**TOWN OF POMFRET
Selectboard**

Memorandum of Decision

Property Address: 19 Dinsmoor Road
Pomfret, Vermont

This Memorandum of Decision (this “Decision”) is issued by the Selectboard of the Town of Pomfret (the “Selectboard”), in connection with the Application for Town Highway Access Road Permit dated August 7, 2023, by Hillary D. White and Philip Dechert (“Applicant”) and attached hereto as Exhibit A (the “White Application”).

PROJECT TITLE:	SHARED ACCESS ENTRANCE TO BARTLETT BROOK
SHEET TITLE:	EXISTING CENTERLINE PROFILE
PROJECT NO.:	2304
SHEET NO.:	C1.10
DATE:	6-12-23

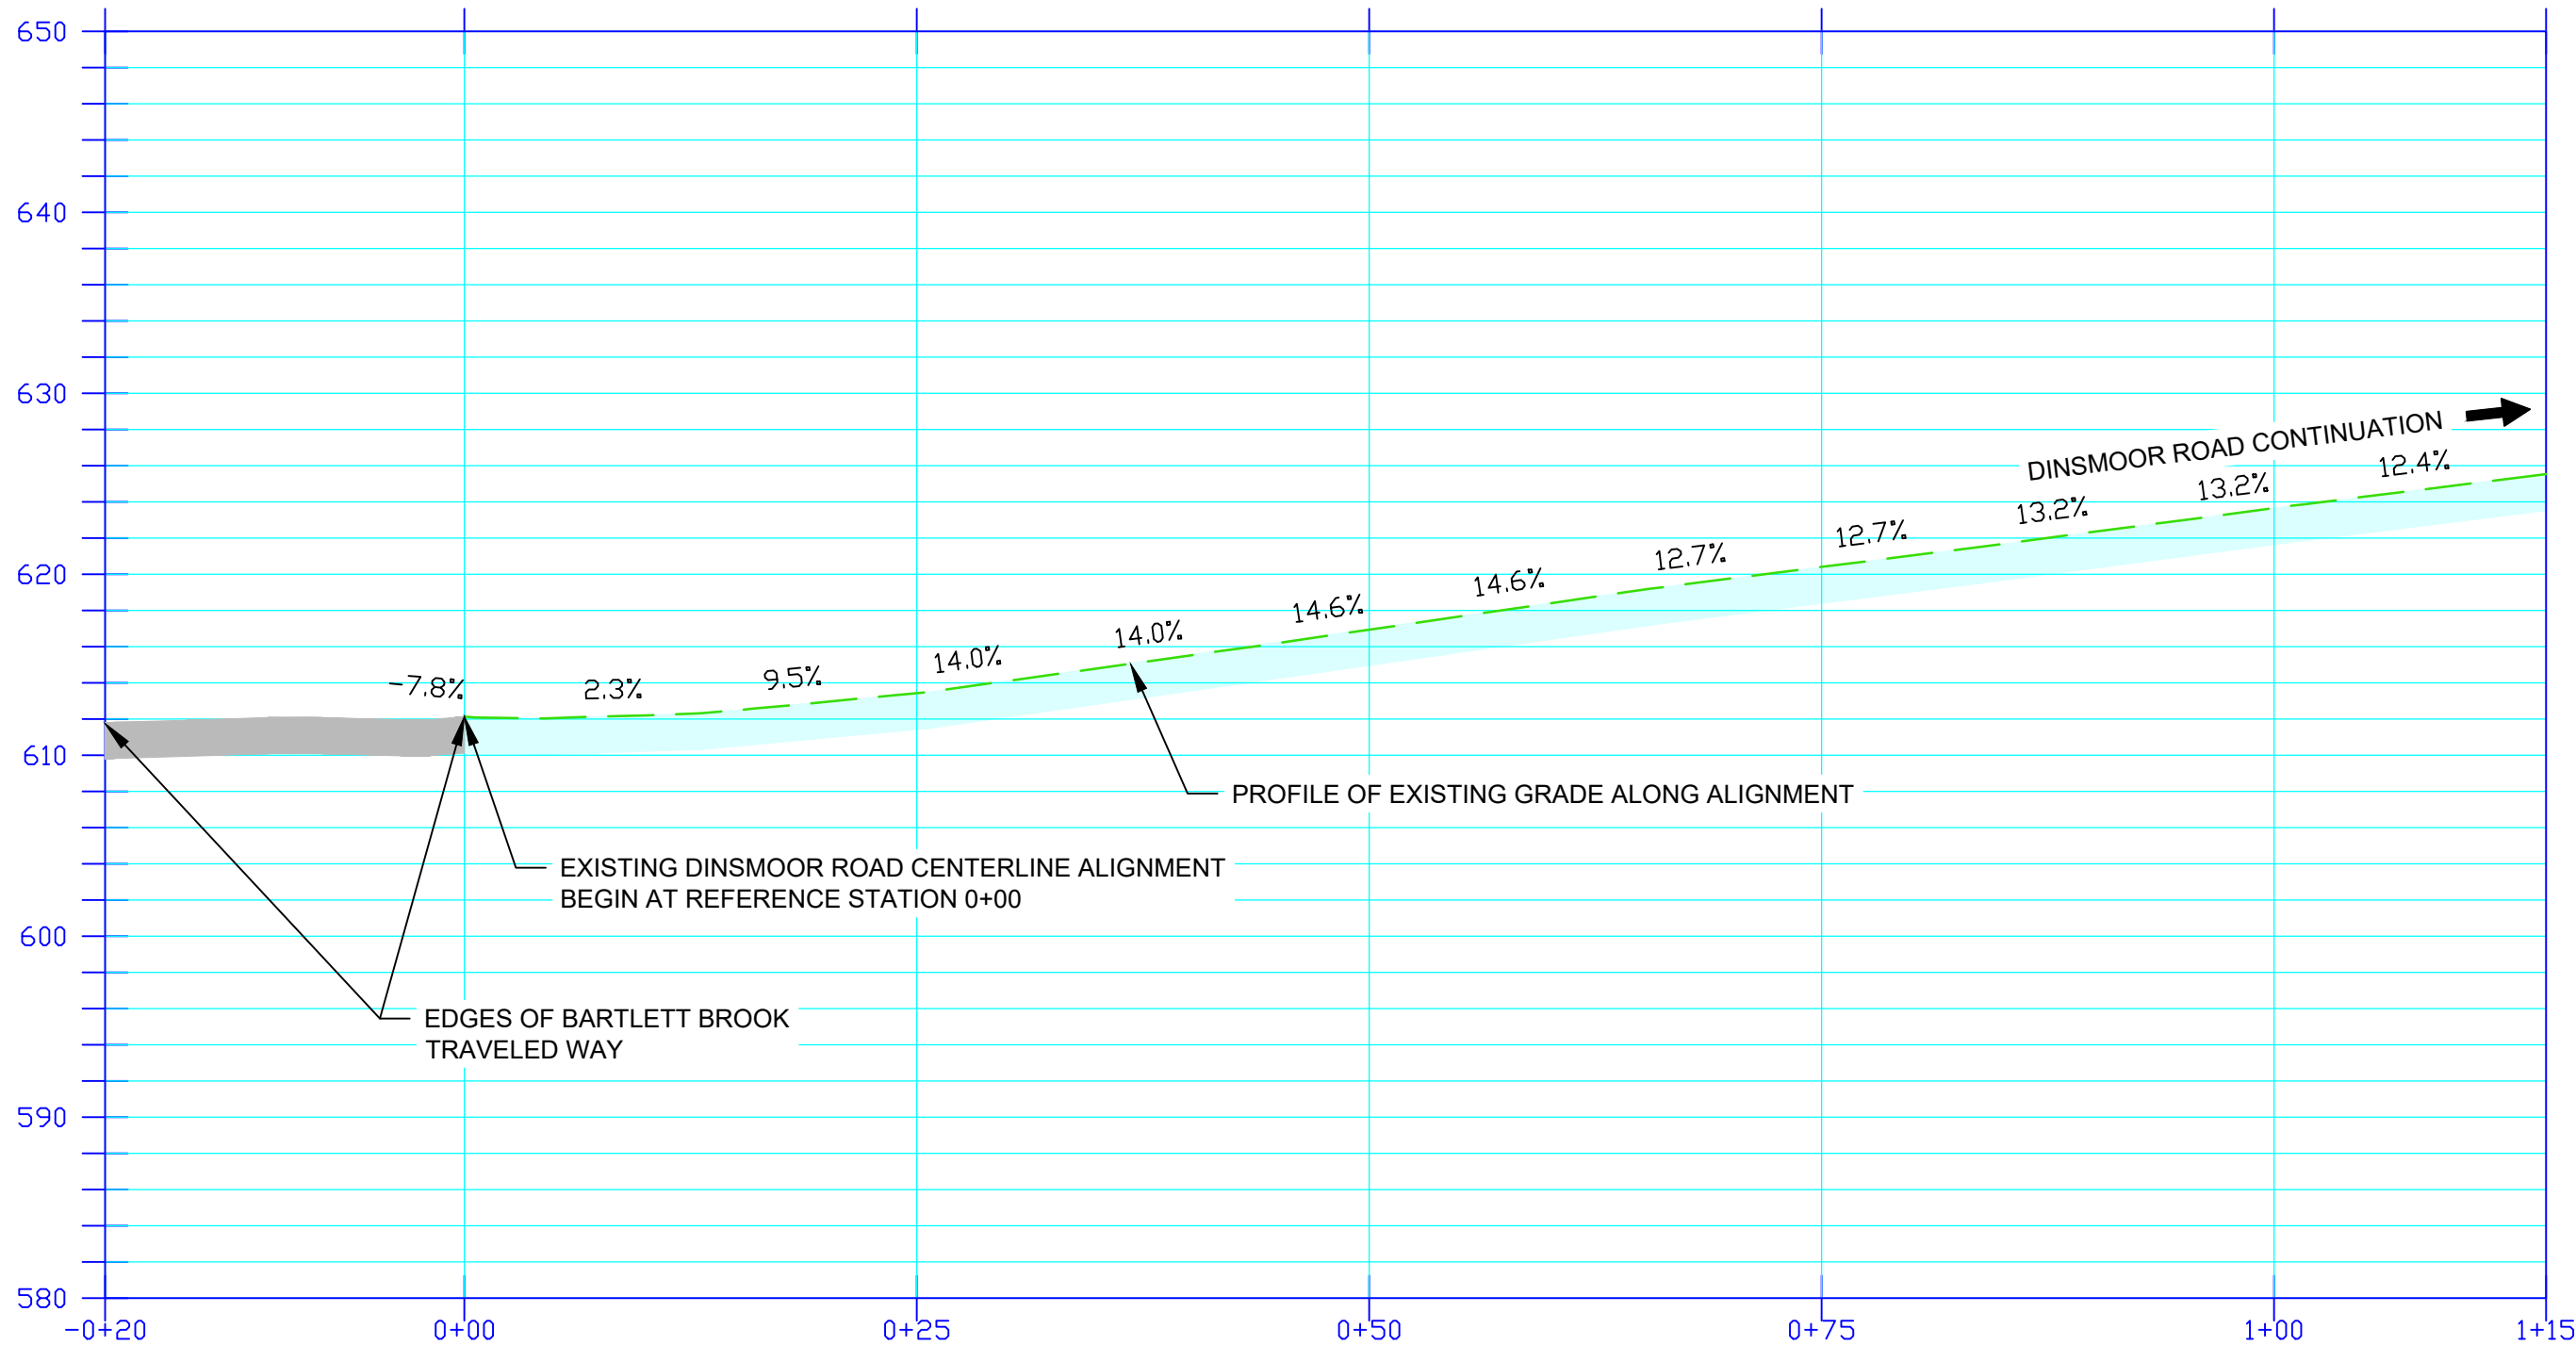
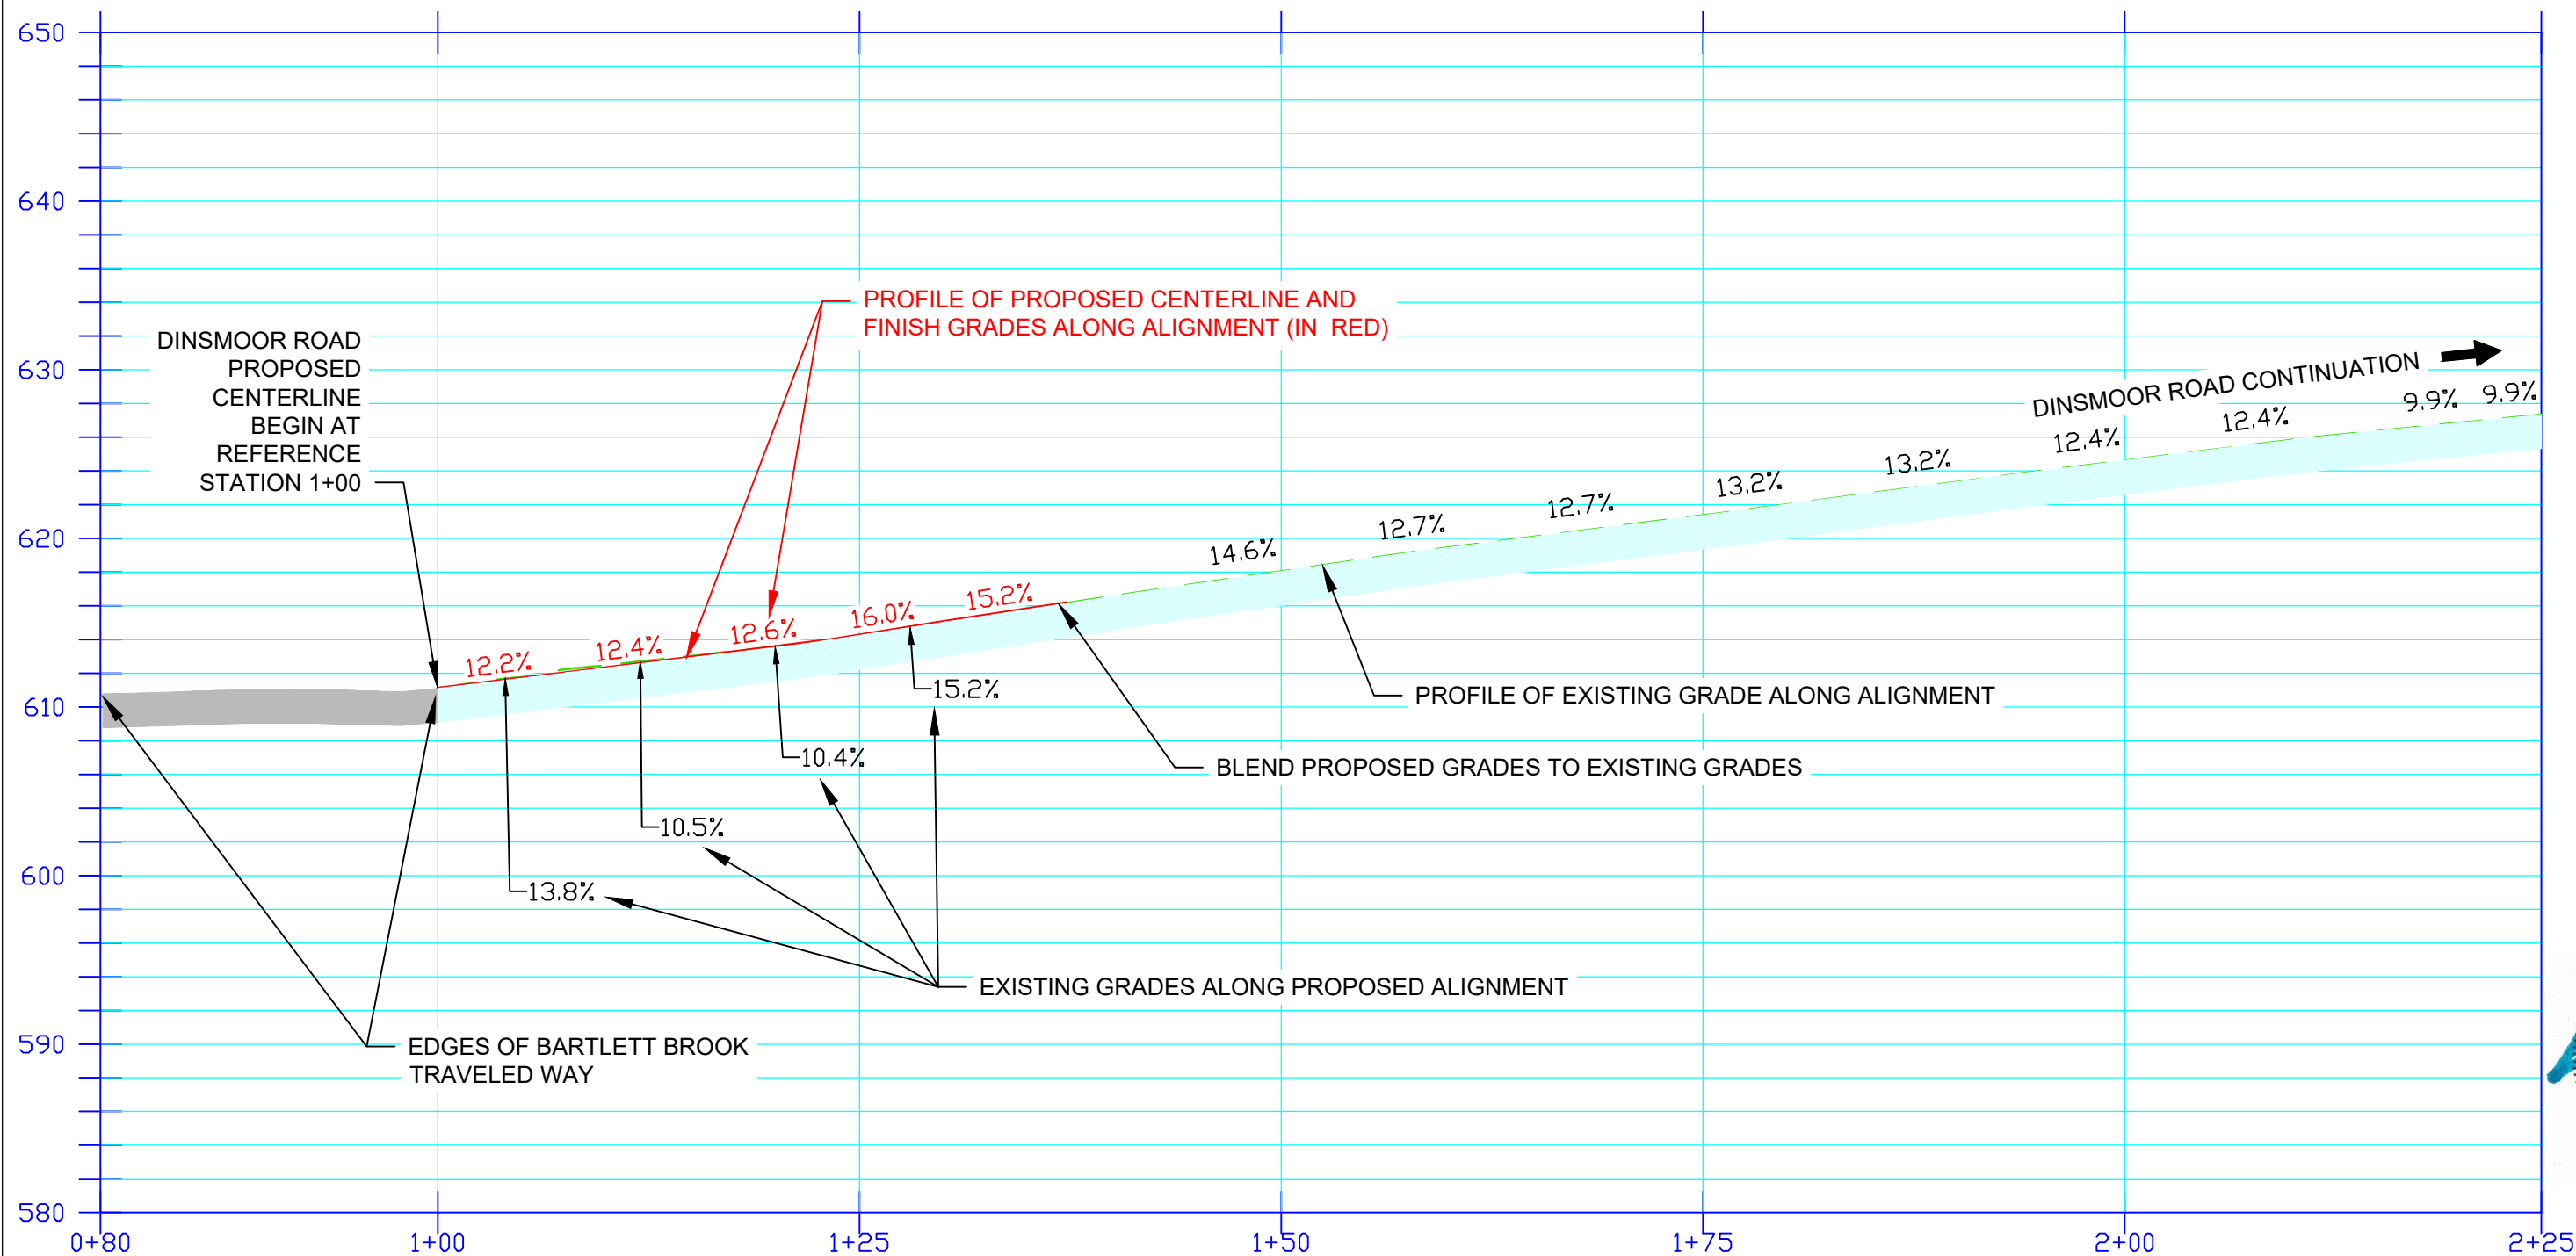
The White Application proposes to address these challenges by establishing a shared access apron south of the existing traveled way of Dinsmoor Road, supported by a precast concrete headwall at the outlet of the existing culvert at the bottom of Dinsmoor Road and running parallel to Bartlett Brook Road. This would result in an approximately 75-degree intersection between Dinsmoor Road and Bartlett Brook Road, versus the more skewed angle that now exists. By shifting the driveway centerline downhill (due to the proposed apron being off-center and down grade from the existing traveled way), the moderate uphill grade would remain, and in some places become modestly steeper.²

² *Compare* Sheet C1.10 with Sheet C2.10 in the MacKenzie Engineering and Construction plans attached hereto as Exhibit B (the “Construction Plans”).
